# Information to ASB2013/02/18

Containment Risk for NA and NR Turbochargers

**MAN Diesel & Turbo SE**  
Business Unit Turbocharger

### Example for test of different versions

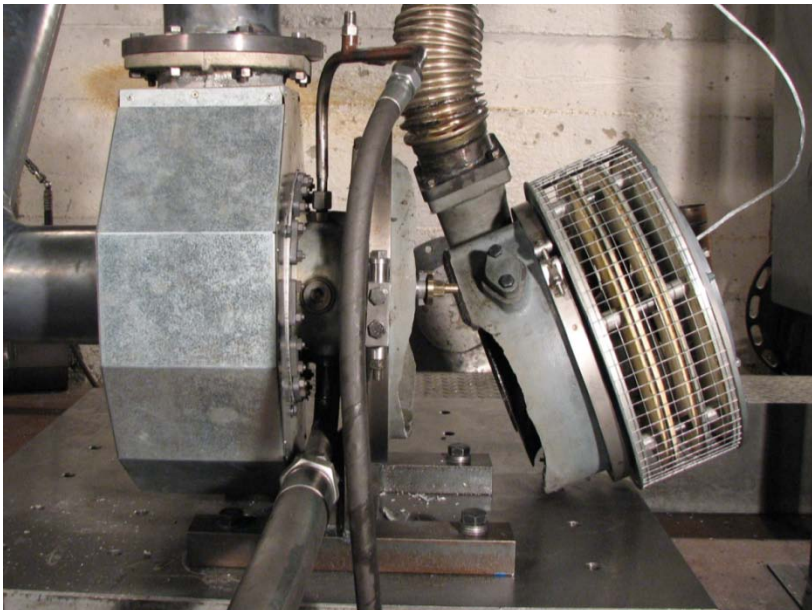
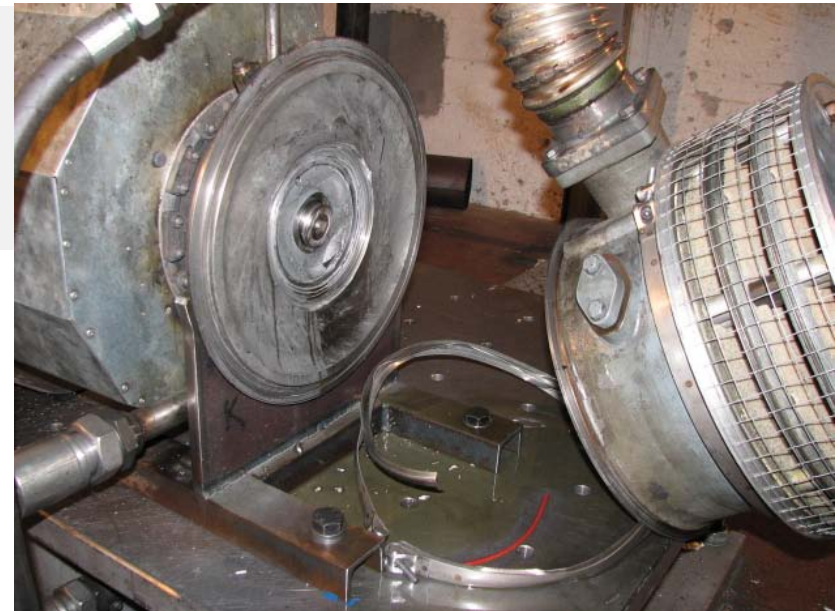
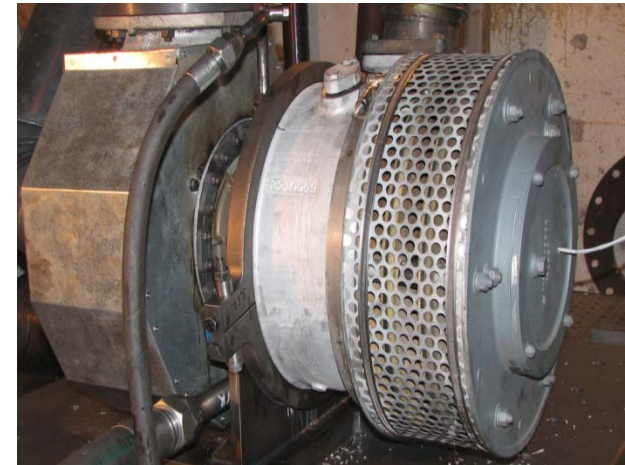
**v-clamp failed**

**grey cast casing failed**

#### Containment safe design with combination of

- Nodular cast compressor casing and
- Improved v-clamp connection between compressor casing and bearing casing

**Containment safety validated**

## Solution concept

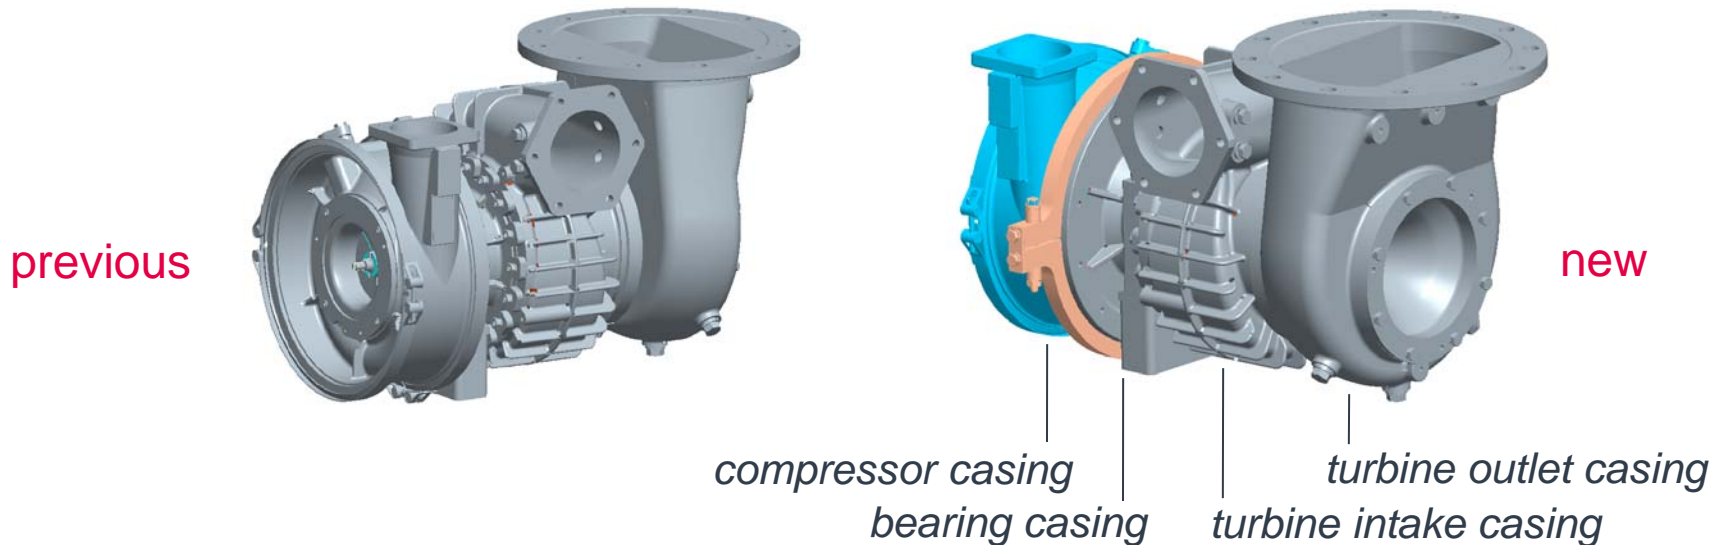
## Problem

With NR and NA turbochargers, the casings and/or the flange connections are not sufficiently strong to withstand extreme load situations which may for example occur in the very rare case of a rotor failure.

- Modification of the casing design (compressor casing, insert piece)
- Modification of connection of compressor and bearing casing
- Scope (number of components) varies per turbocharger type
